NON-COMPLIANCE REPORT # 31734-74

PART NAME: SHAFT END BRACKET
 PF/SA NO.: PF-391-738-25 R0
 WORK ORDER NO.: 31734-74
 VENDOR: KLY MACH SHOP

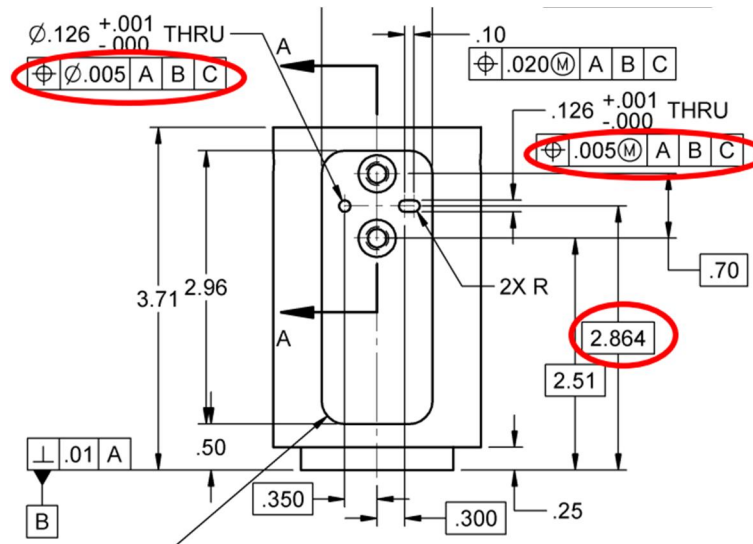
Reason for Non-Compliance:
1 rejected, 2 accepted

1. $\boxed{\text{M} \text{ } \phi .005 \text{ } A \text{ } B \text{ } C}$ of $\phi .126 \begin{smallmatrix} +.001 \\ -.000 \end{smallmatrix}$ THRU is out of true position measuring 0.0094 on SN 104 only.
 - a. 2.864 measured 2.8593
2. $\boxed{\text{M} \text{ } \phi .005 \text{ } A \text{ } B \text{ } C}$ of $\phi .126 \begin{smallmatrix} +.001 \\ -.000 \end{smallmatrix}$ THRU is out of true position measuring 0.0081 on SN 104 only.
 - a. 2.864 measured 2.8600
